Ávila (Spain)

No 348 rev

<i>State Party:</i>	Spain
<i>Name of property:</i>	Old Town of Ávila with its Extra Muros Churches
<i>Location:</i>	Province of Ávila, Autonomous Community of Castile-Leon
<i>Inscription:</i>	1985

Map showing the minor modification to the boundaries of the core zone and the proposed buffer zone

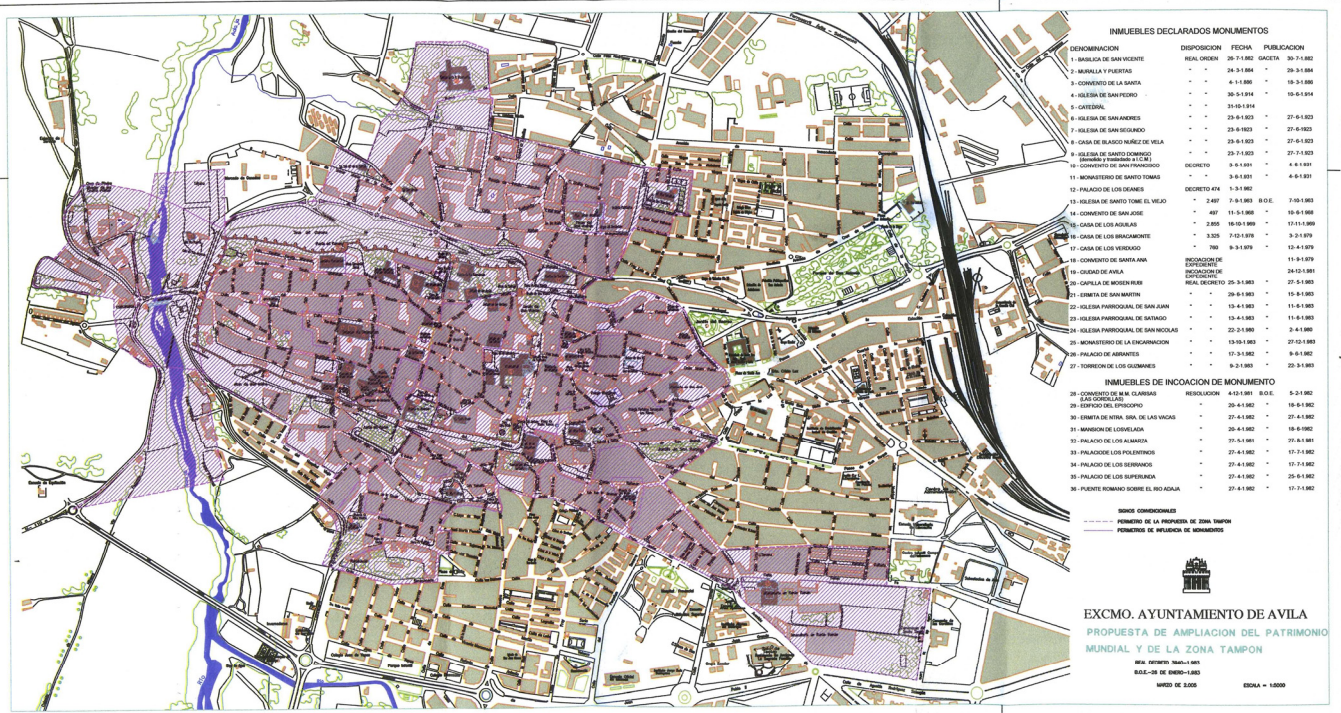
ICOMOS considers that the proposed buffer zone and the protective legislation applying to it, will enhance the protection of the inscribed property and the proposed additions to the property. Nevertheless the irregular boundary of the buffer zone and the fact that part of the inscribed property still remains with little protection of its immediate setting makes it difficult to understand the rationale for the boundary of the proposed buffer zone. Given that the town is on a high mound and that there are views out from it, there is a need to protect the most important views to and from the town. There is no mention of this approach in the documentation submitted with the buffer zone.

ICOMOS considers that the State Party should explain the rationale behind the proposed boundary of the buffer zone and how key views to and from the property might be protected.
